TRANS/WP29/GRSP/2004/27
21 October 2004

**DRAFT CORRIGENDUM 2 TO SUPPLEMENT 15 TO THE 04 SERIES
OF AMENDMENTS TO REGULATION No.16**

(Safety belts)

Submitted by the experts from International Organization of Motor Vehicle
Manufacturers (OICA) and European Association of Automobile Suppliers (CLEPA)

Figure 1 – ISO/F3 envelope dimensions for a full-height forward-facing toddler CRS (height 720 mm) - ISOFIX SIZE CLASS A

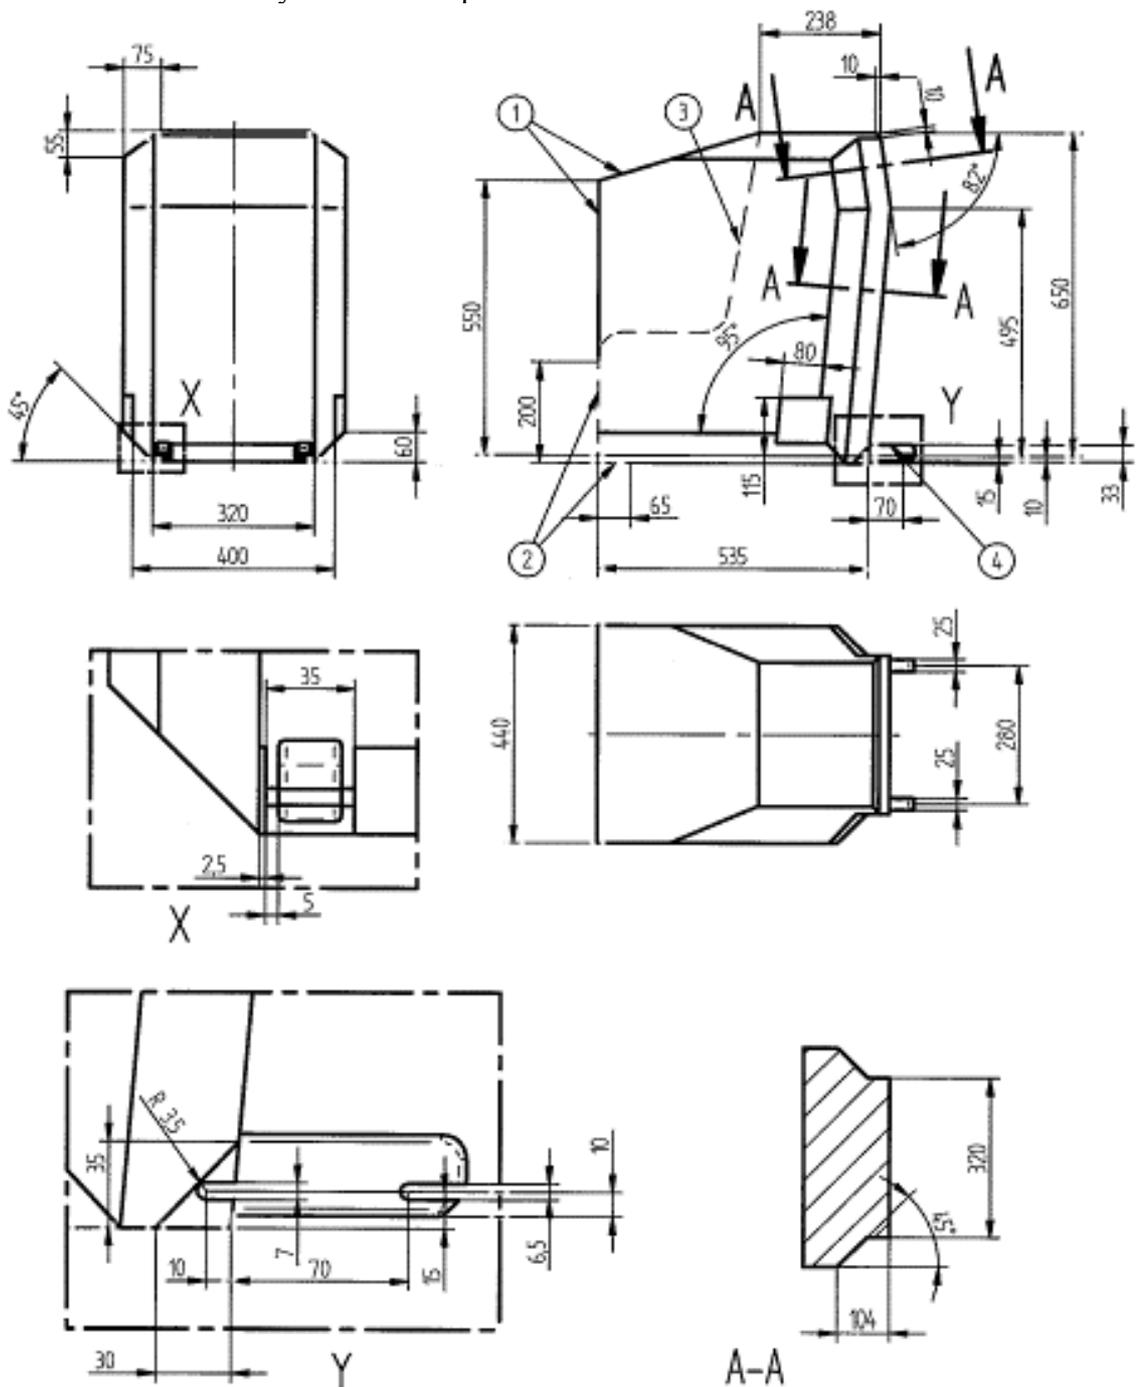
Annex 17, paragraphs 4.1.to 4.7., replace by:

"4.1. Full-height forward-facing toddler child restraint systems envelope

- 1 Limits in the forward and upwards directions
- 2 Dashed line marks area where a support leg, or similar, is allowed to protrude
- 3 N/A
- 4 Further specifications of the connector area are given in Regulation No. 44

Figure 3 – ISO/F2X envelope dimensions for a reduced-height second version back surface forward-facing toddler CRS, (height 650 mm) – ISOFIX SIZE CLASS B1

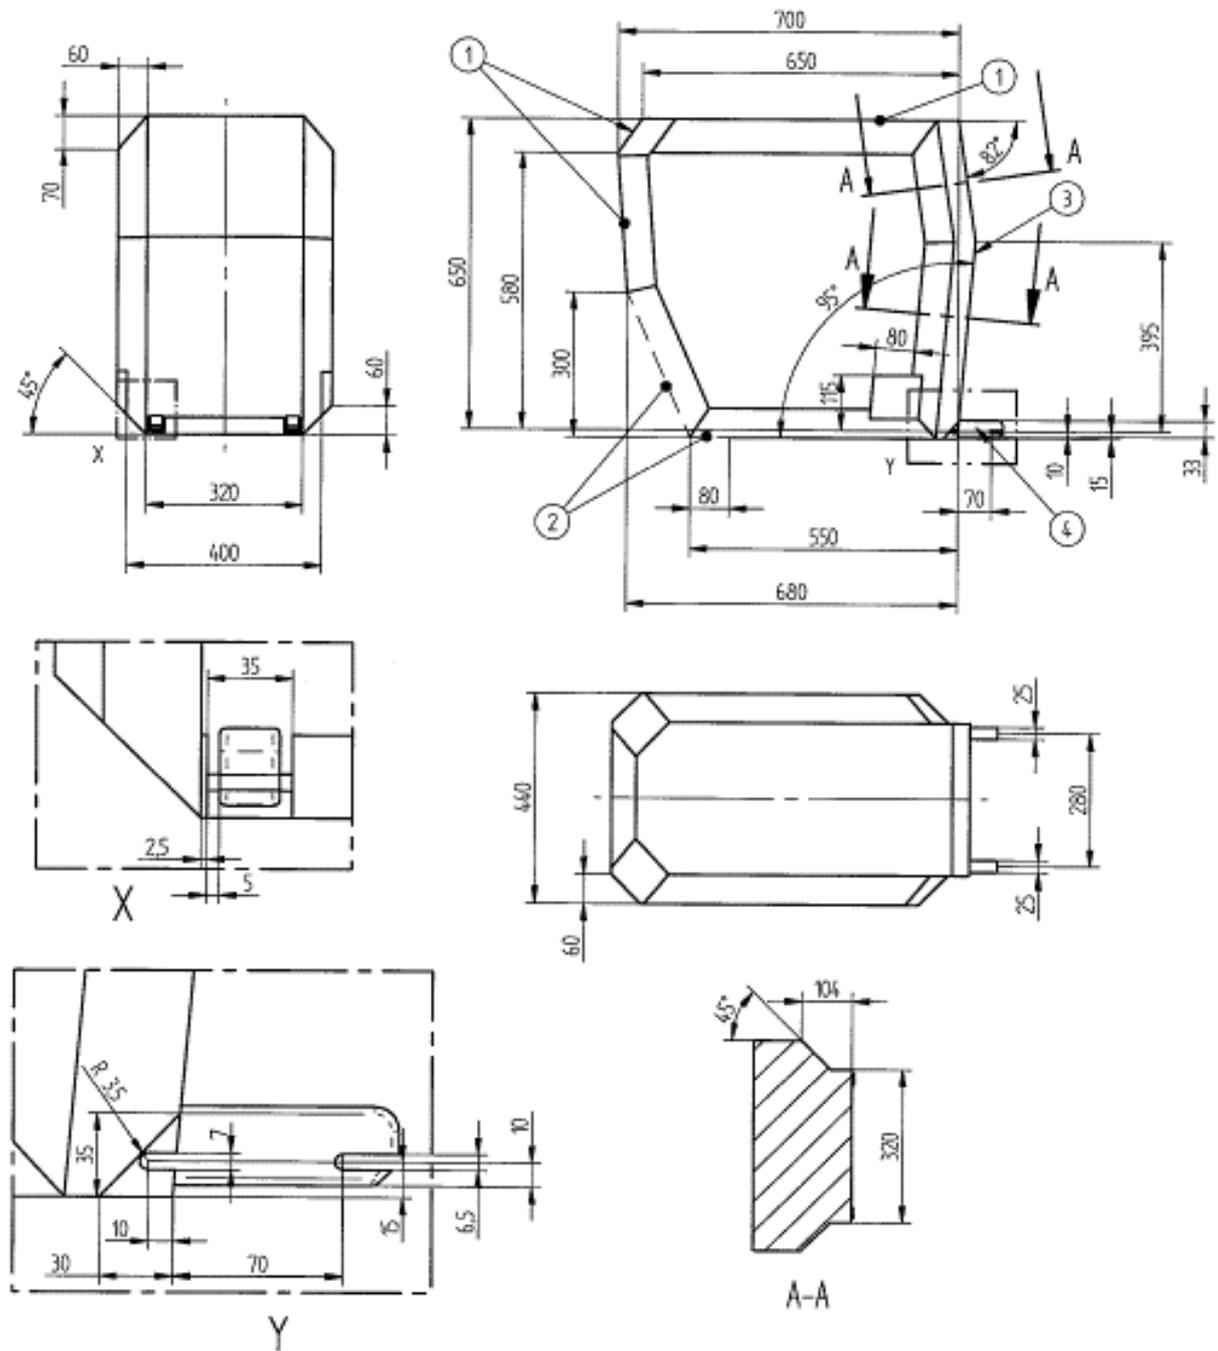
4.3. Reduced-height second version back shape forward-facing toddler child restraint systems envelope

- 1 Limits in the forward and upwards directions
- 2 Dashed line marks area where a support leg, or similar, is allowed to protrude
- 3 N/A
- 4 Further specifications of the connector area are given in Regulation No. 44

Figure 5 – ISO/R2 envelope dimensions for a reduced-size rearward-facing toddler CRS – ISOFIX SIZE CLASS D

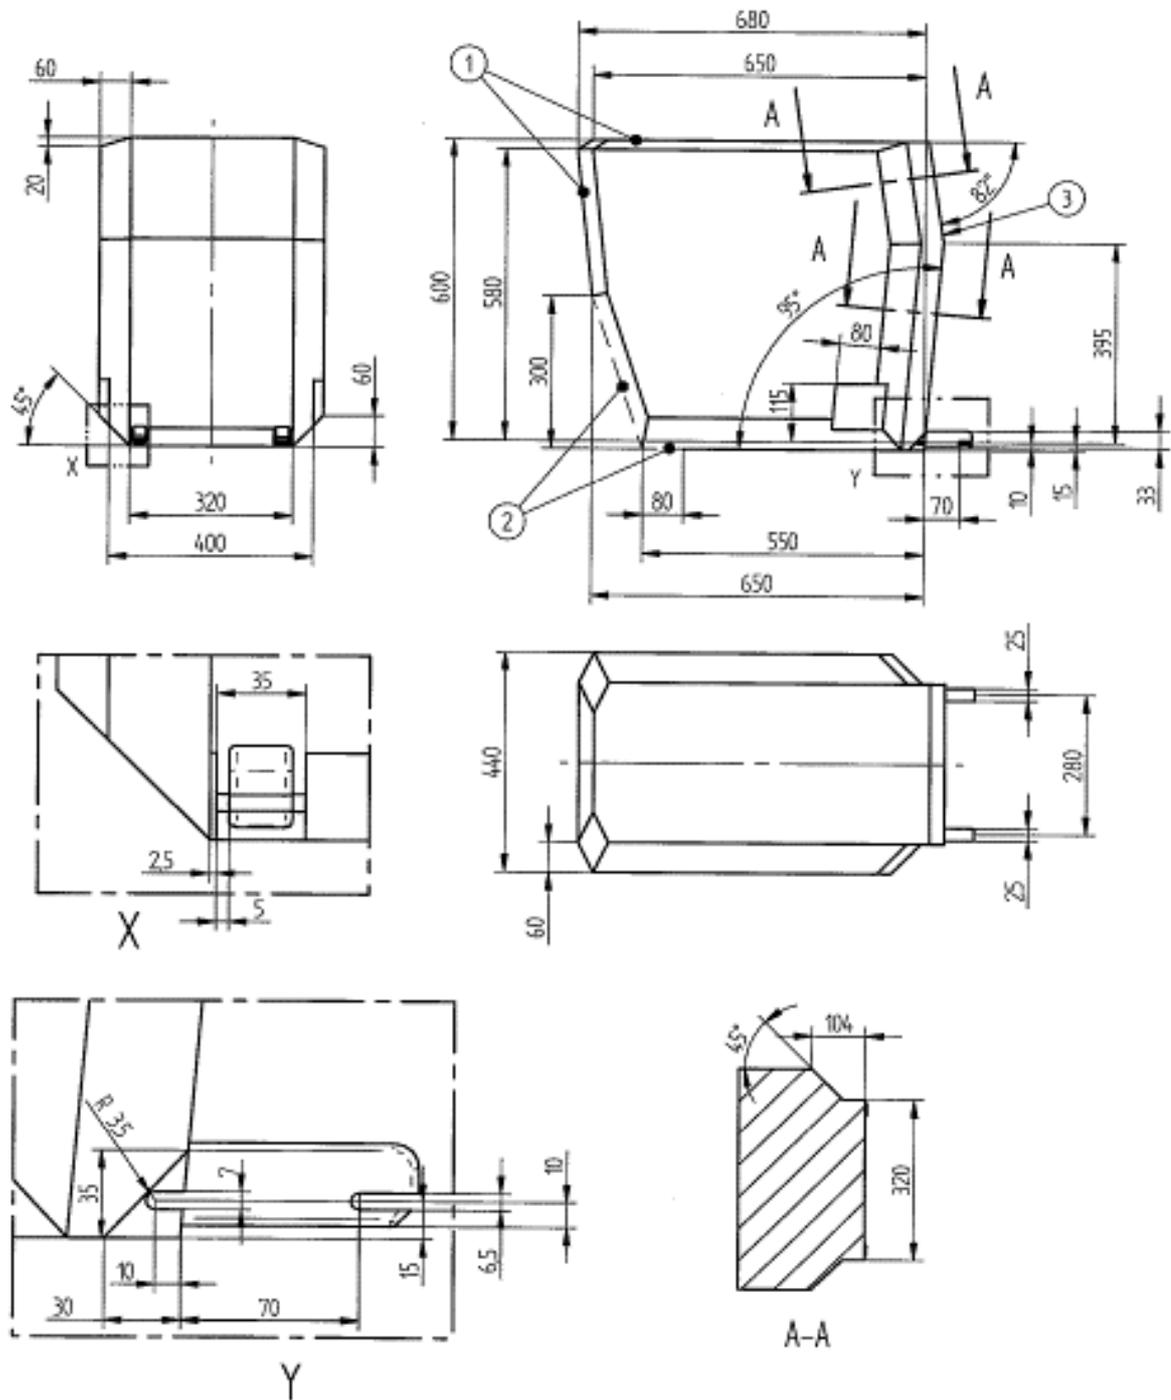
4.5. Reduced-size rearward-facing toddler child restraint systems envelope

- 1 Limits in the rearward and upwards directions
- 2 Dashed line marks area where a support leg, or similar, is allowed to protrude
- 3 The backwards limitation (to the right in the figure) is given by the forward-facing envelope in Figure 2
- 4 Further specifications of the connector area are given in Regulation No. 44

Figure 6 – ISO/R1 envelope dimensions for an infant-size rearward-facing CRS – ISOFIX SIZE CLASS E

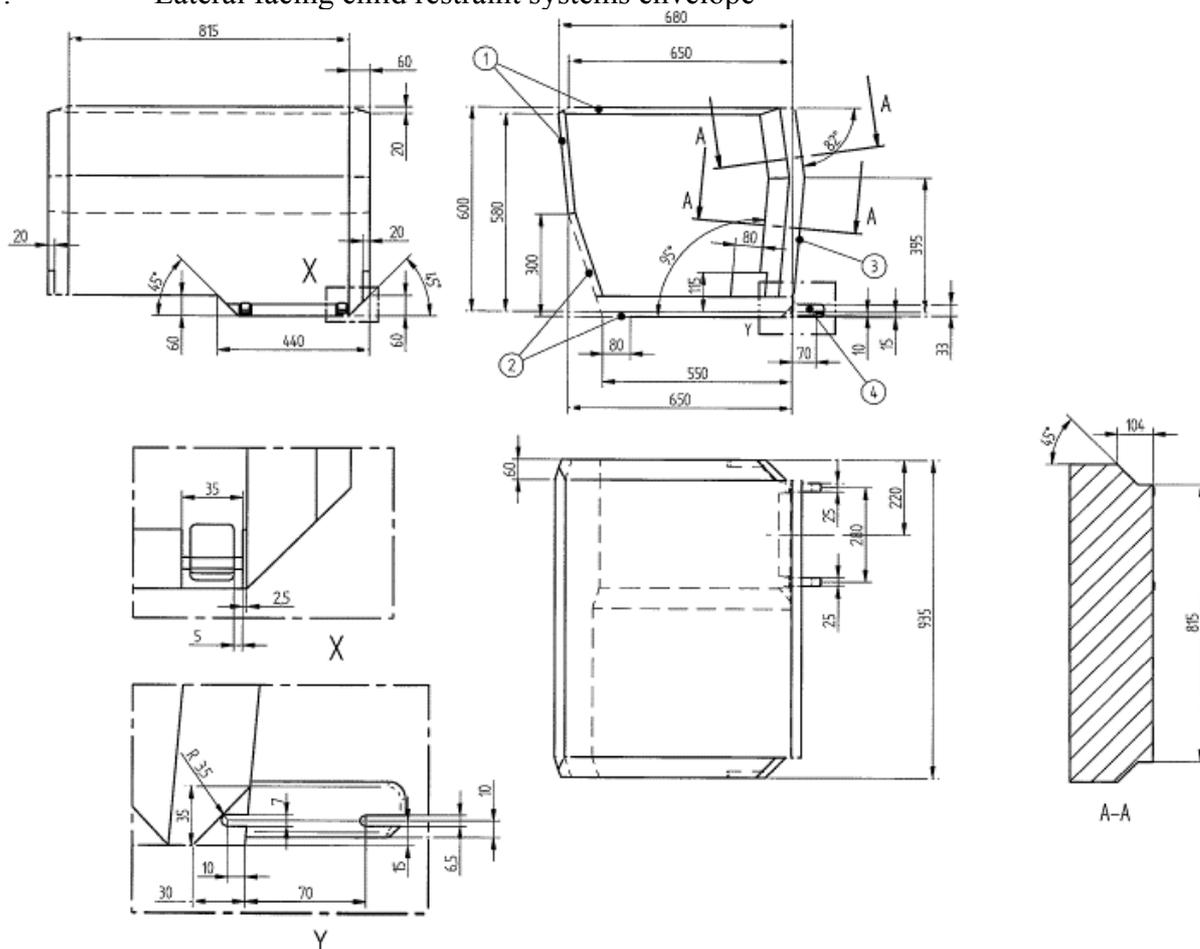
4.6. Rearward facing infant child restraint systems envelope

- 1 Limits in the rearward and upward directions
- 2 Dashed line marks area where a support leg, or similar, is allowed to protrude
- 3 The backwards limitation (to the right in the figure) is given by the forward-facing envelope in Figure 2
- 4 Further specifications of the connector area are given in Regulation No. 44
